TWT ST LEONARDS 23-35 ATCHISON STREET, ST LEONARDS

APRIL 2017

This report has been prepared to address the urban design issues in comments made by North Sydney Council (NSC) in a letter dated 5 April (*CONCEPT FOR 25-35 ATCHISON STREET, ST LEONARDS*) in response to the submission of a preliminary concept proposal on 14 March 2017.

Fig. 7.01 Proposed Ground Plane Diagram

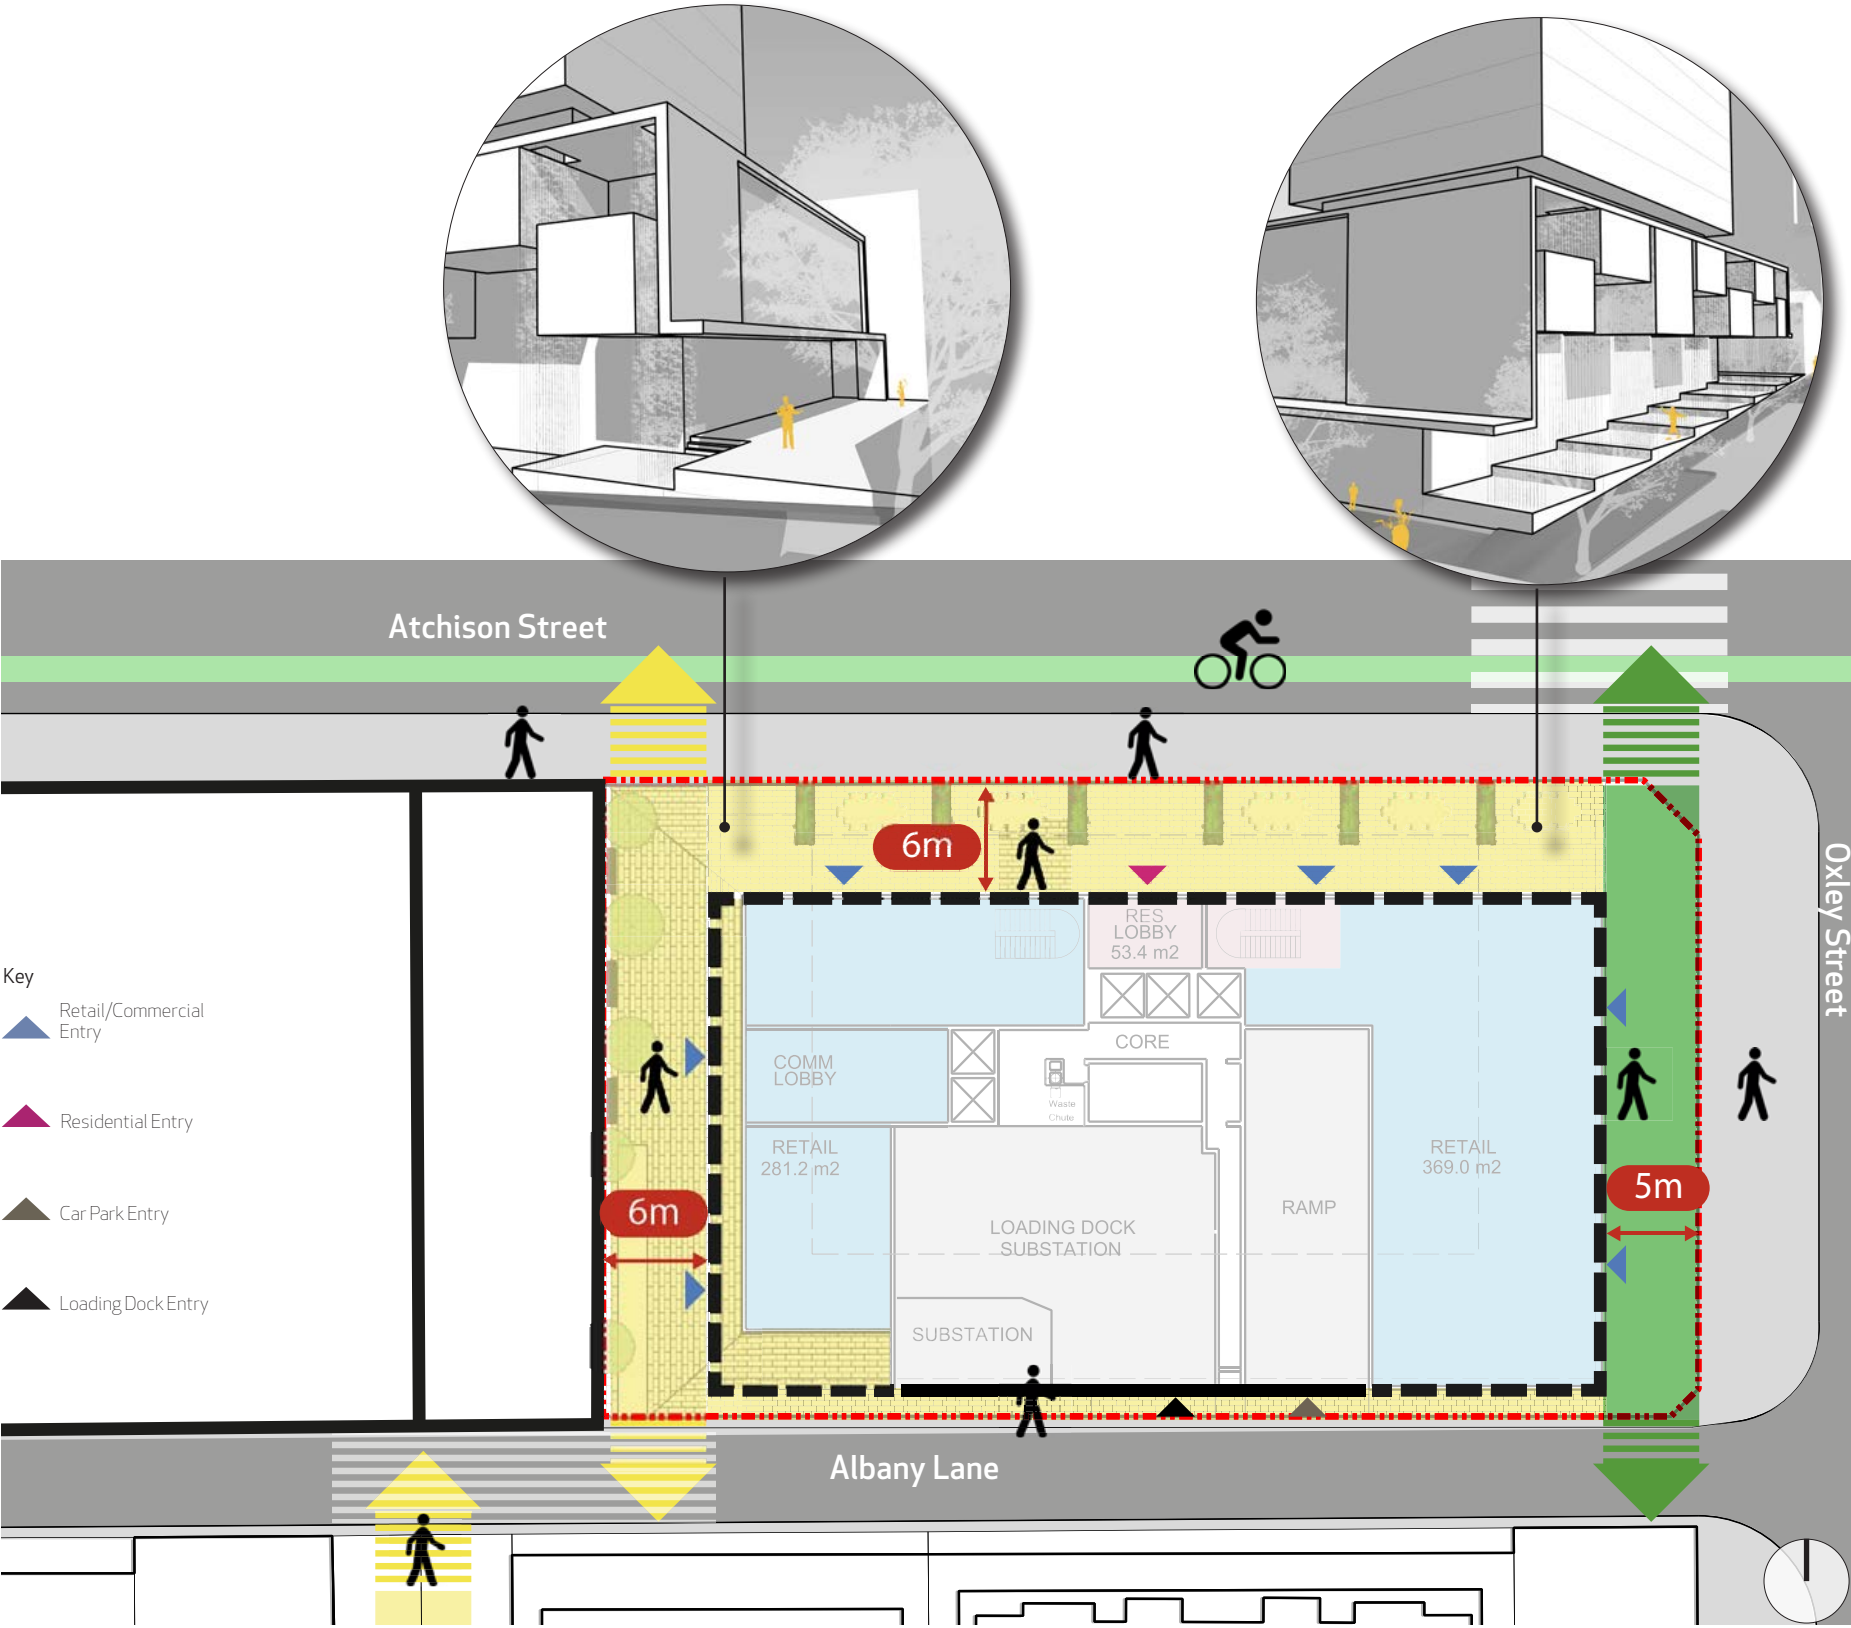
NSC : “Please submit a ground plane design that shows entry points to the retail tenancies, commercial floors and residential apartments car access and any open air laneway.”

A Proposed Ground Plane/Public Domain Diagram (Fig. 7.01) is shown here to further explain these points.
